Product Change Notification

PCN-ICC-4868-2020

Business Unit	Product Line Code	Type of Change	Action	Date of Issue
ICC - Industrial Cabinet	BE2	Product Change Notification	Notify Distributors and Field	1/7/2020

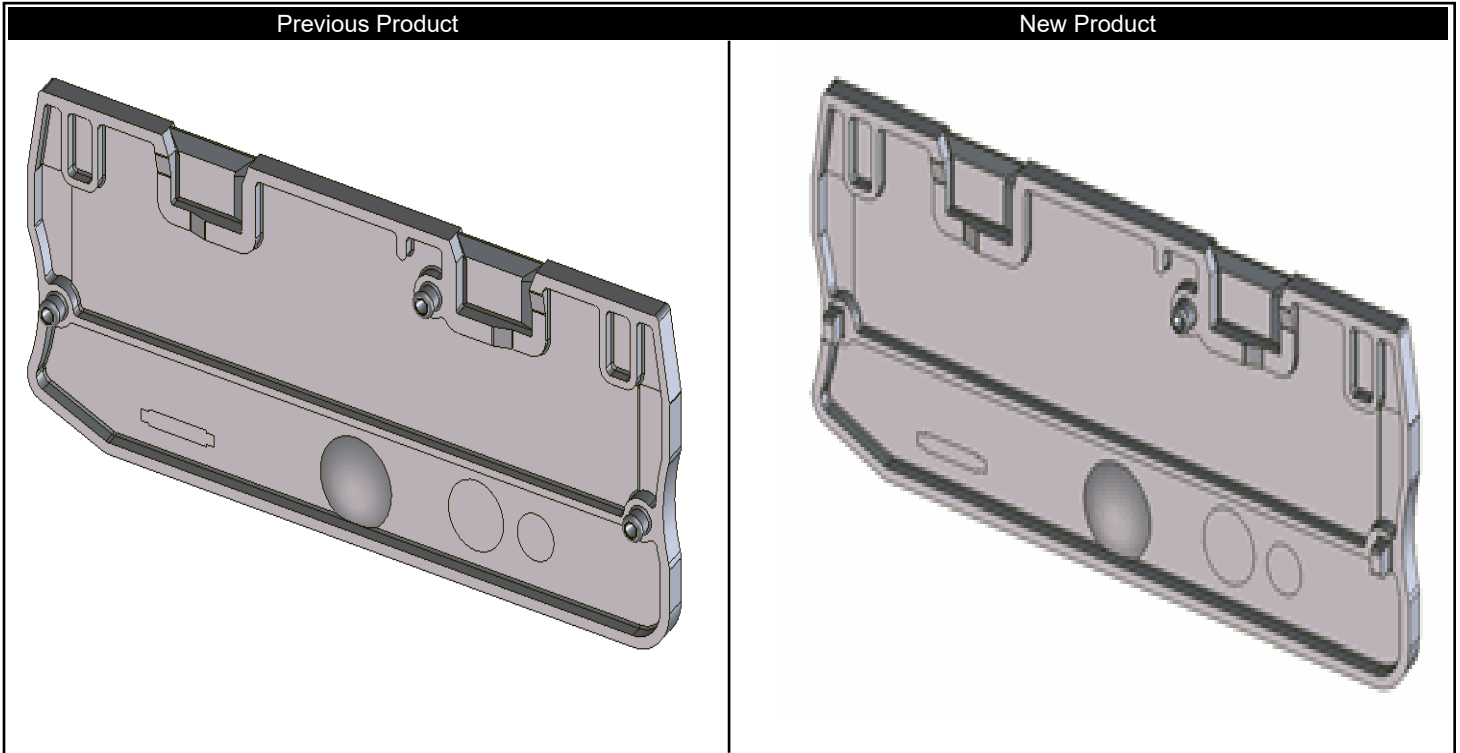
The change effects the snapping pin of the covers which are changed slightly to achieve an improved fitting . Therefore some pins are changed from round to rectangular. This change has no influence to the compatibility or the electrical performance of the products. Old and new shape are interchangeable, with the exception of the following...

- 1.It is not possible to mix the **old V/C** of D-PT 2.5-MT and D-PT 2.5-MTB with the **new V/C** of terminal block PT 2.5-MT/TG and PT 2.5-MTB in that case the covers need to be replaced
- 2.The mix of the new V/C of D-PT 2.5-MT and D-PT 2.5-MTB with the old V/C of terminal block PT 2.5-MT/TG and PT 2.5-MTB is possible
